## DRAINAGE AND TRANSPORTATION INFORMATION SHEET (REV 09/2015)

RE: **Navarette Residence**  
**10516 Olympic NW**  
**Grading Plan**  
**Engineer's Stamp Date 6/14/17 (File: A12D028)**

Based on the information provided in your submittal received 6/21/17, the Grading Plan cannot be approved for Building Permit until the following are addressed:

SECTION B-B  
NTS

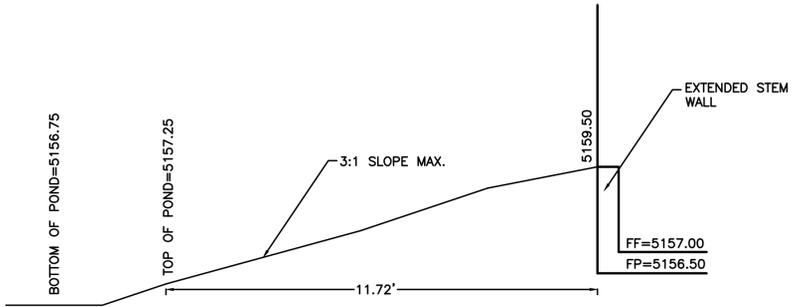
1. Section Views. Provide section cuts of several areas across this site:
  - a. The southwest corner, between the SW corner of the house, to the adjoining lot to the south. **ADDED SECTION C-C**
  - b. In the back yard, through the two retaining to the property to the east.
  - c. The northwest corner, between the NW corner of the garage to the adjoining property to the north. **ADDED SECTION A-A**
  - d. In the northeast corner, through the lowest floor at 5157.00 and the ponding area. **ADDED SECTION B-B**

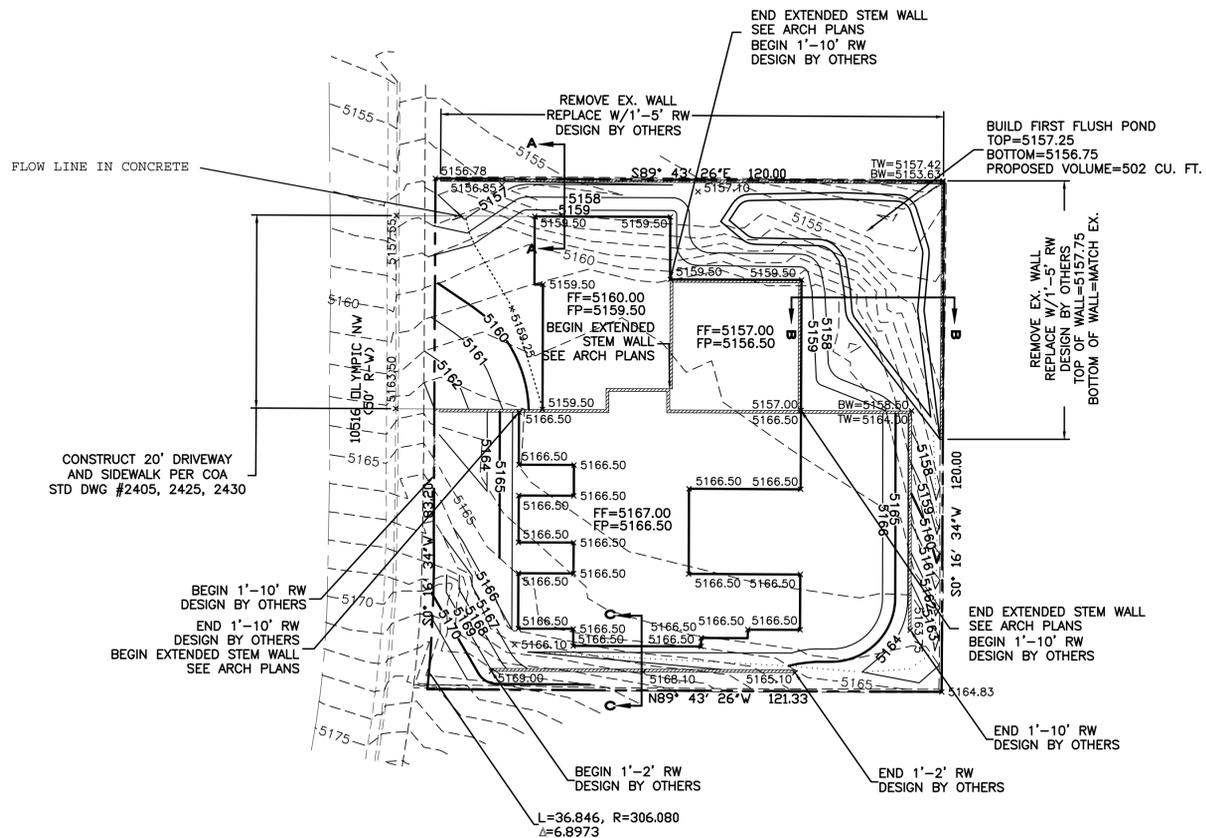
Ensure these section views show that the flowline is not set against any retaining walls or walls of the house and ensure below-grade finished floors have waterproofed retaining walls. **ADDED NOTE #4**
2. Contours. Extend the topographic data around all of the lot lines, not just on the west side of the lot. Also label contours for existing and increase label density of the proposed contours. **WE HAVE LABELED AND VERIFIED ALL CONTROURS SHOWN**

- NOTES:**
1. ALL SPOT ELEVATIONS REPRESENT FLOWLINE ELEVATION UNLESS OTHERWISE NOTED.
  2. ALL SLOPES SHALL BE 3:1 MAX. AND GRAVEL OR NATIVE SEEDING PRIOR TO CO.
  3. ANY PERIMETER WALLS MUST BE PERMITTED SEPARATELY. ALL RETAINING WALL DESIGN SHALL BE BY OTHERS.
  4. ALL BELOW GRADE STRUCTURES SHALL BE WATERPROOFED
  5. SLOPE OF DRIVEWAY HAS BEEN AUTHORIZED BY OWNER. GARAGE SLAB SHALL HAVE 1/2 LIP AT GARAGE DOOR TO PREVENT DRAINAGE FROM ENTERING GARAGE
  6. SITE IS NOT IMPACTED BY UPLAND FLOW
